August 10, 2018

Product Change Notice - Electric leveling bolts

Fig.1

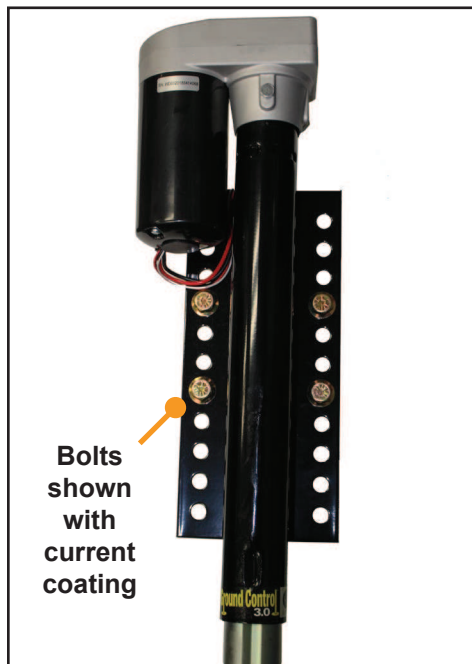
This improvement pertains to the mounting bolts for our electric leveling jacks (**Fig. 1**). Currently, the electric leveling bolts have a zinc coating with salt spray resistance exceeding 50 hours. We intend to improve the bolts on or around 08/27/18. At this time, we intend to improve the corrosion resistance and utilize bolts coated with zinc flake with Magni 567 topcoat to increase the salt spray resistance to 1,000 hours. We previously made the same change to our hydraulic leveling bolts.

Fig.2

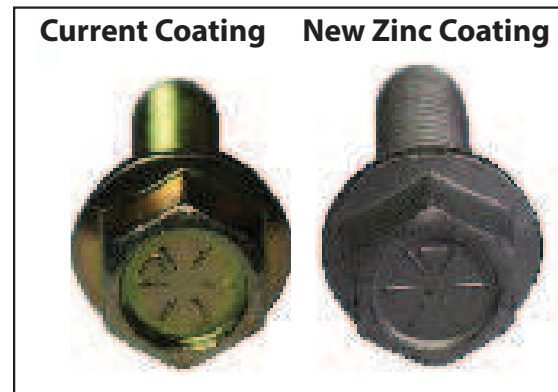
In (**Fig. 2**) are a current production bolt (left) that will move to the zinc flake with Magni 567 topcoat with salt spray resistance of 1,000 hours (right).
